BID ADDENDUM 3

Project: Warwick Valley CSD
High School
Renovations, Field Work, Roofing and Exterior Bathroom Building

Engineer: Eisenbach & Ruhnke Engineering, P.C.
291 Genesee Street
Utica, NY 13501
E&R Project #: 05-21-04

4 150 GALLON HOLDING TANK DETAIL
SCALE: NONE

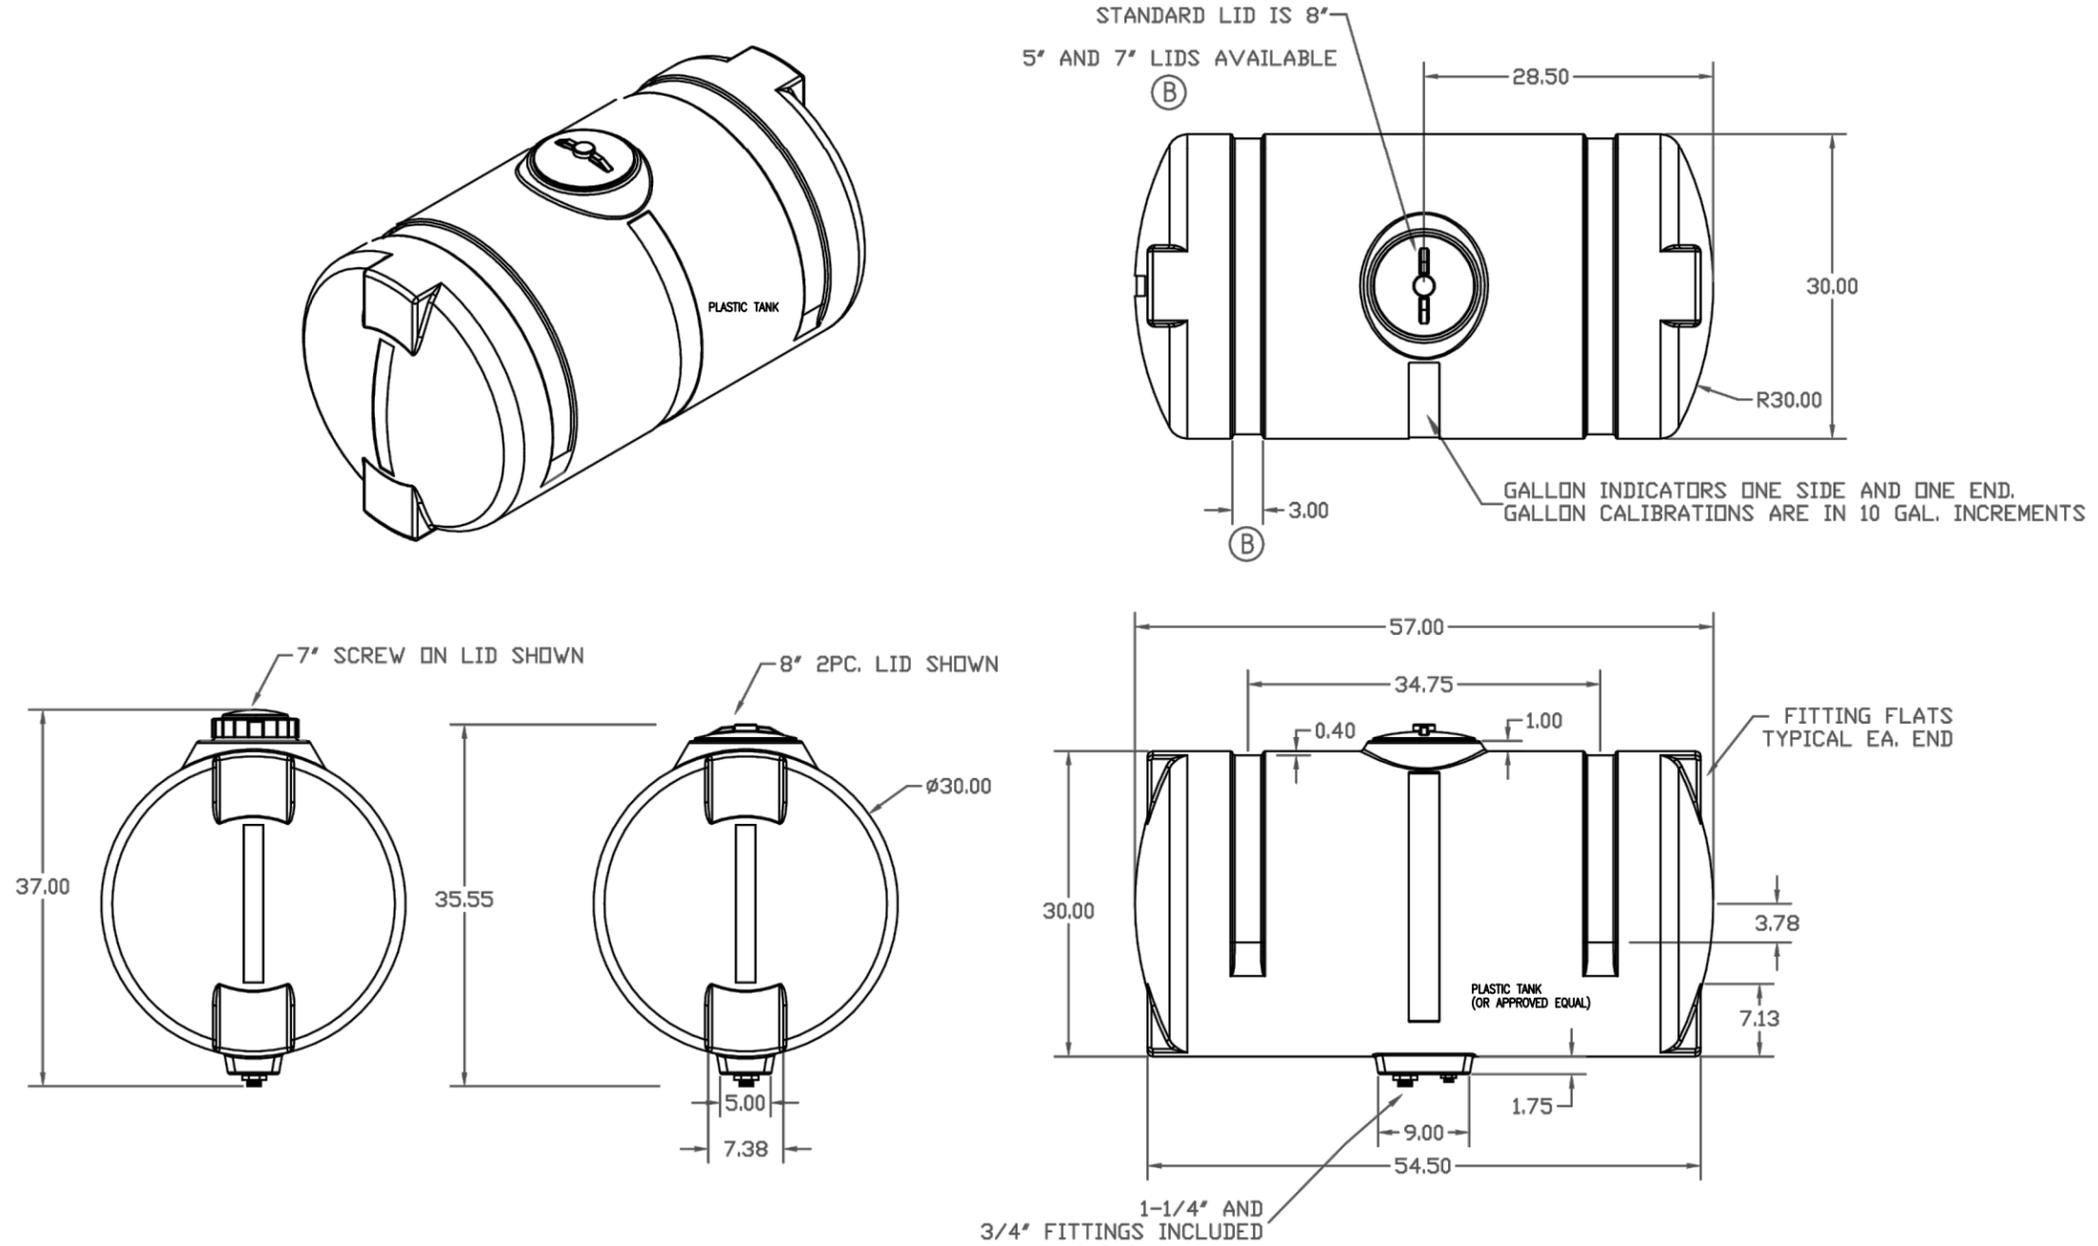
SUBJECT: 150 Gal Water Holding Tank

Drawing BB P-100 dated 5/3/22 shows (1) 150 water holding tank.

- Is it Existing or New? NEW

- If new who's providing it? Plumber

- If PC is to provide and install – Please provide specs. See Attached Sketch P-100
